Field Memo Report

To: Mr. Steve Routon (Steven Routon Architect, LLC)
From: Jason E. Stanek, PE
CC:
Date: November 3, 2012
Re: 12-082.Routon-Michelinie.Accessory Dwelling Unit.4602 NE 29th Avenue,
Portland, OR, 97211

This field memorandum is regarding a field question that has come up for the interior post base anchorage and diagonal brace connection at the loft landing support. This memo is intended to be in response to this field question.

DIAGONAL BRACE

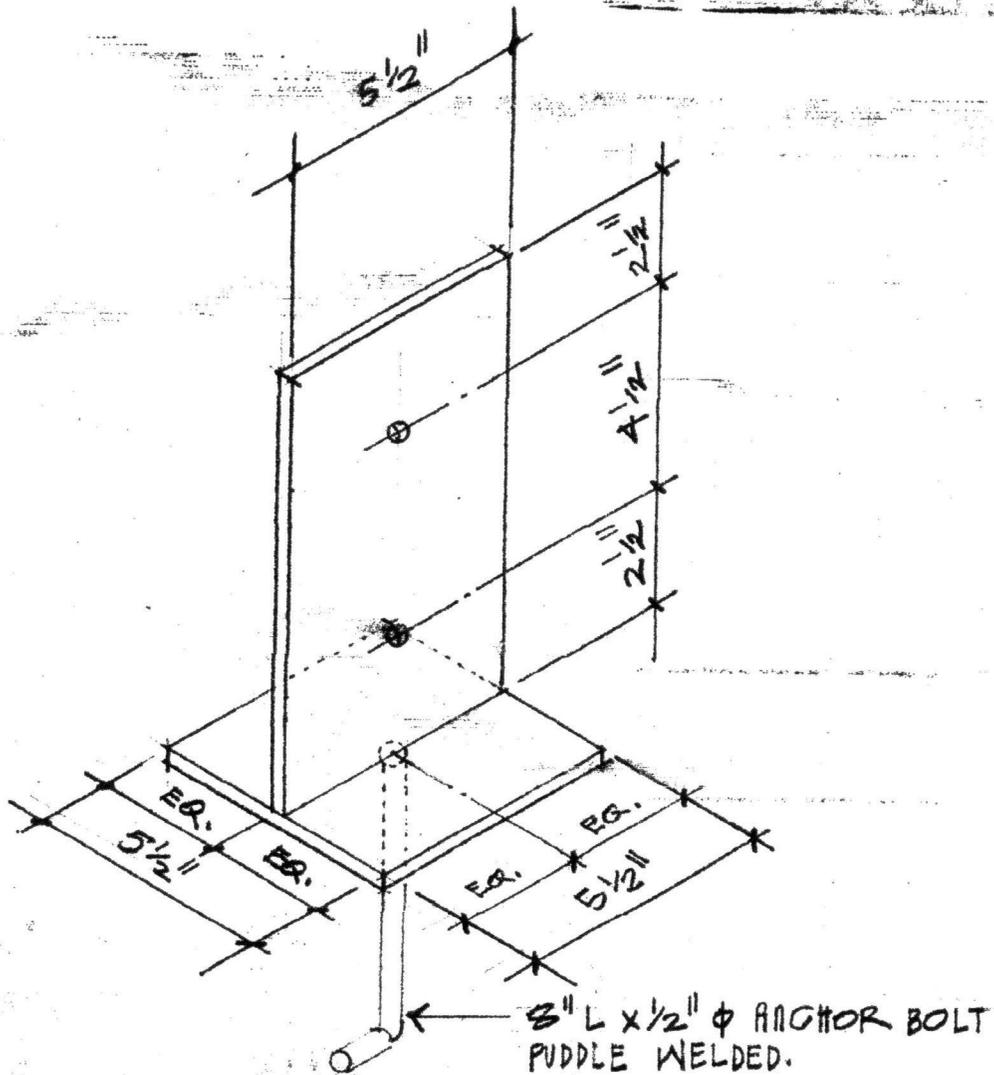
Question: During our construction process, we decided to improve the interior post base connection that supports the loft framing such that it is a more aesthetically pleasing exposed connection, yet still serve its purpose. In lieu of the Simpson post base connector that you specified, we developed a base plate with an anchor bolt welded to it, and then a knife plate welded to the base plate with 2 bolts through the post. Additionally, in the diagonal brace at this same interior area at the base, we have a similar connection with anchor bolt and knife plate, and then at the top, the same knife/base plate, but with a through bolt in the support beam (see sketches attached herewith for all pieces). Are these connectors adequate to carry the loads, and provide the function needed structurally?

Answer: Yes. Per our review of the interior bearing conditions at the base, there is literally no uplift on this connection point, so the original base connector specified was mostly to hold post base in place so it is not disrupted from people passing by. Therefore, your post base/knife plate connection appears to be structurally acceptable for this connection. Additionally, the diagonal brace connectors also appear to be structurally acceptable due to the relatively light loading condition on the loft landing. Worst case loading condition would be for a person standing on the loft at the end of the beam. We will assume a 300 lbs. person at the end of the beam. Please refer to the quick calculations for this condition and the forces involved with the bolts in the connections.

$$\cos 15 = \frac{300}{R}$$

$$R = \frac{300}{\cos 15} = 290 \# \quad \therefore \quad 2 \text{ BOLTS}$$

$$\cos 75 = \frac{V}{290}$$

$$V = 290 (\cos 75) = 75 \#$$

145# / BOLT ✓ ok
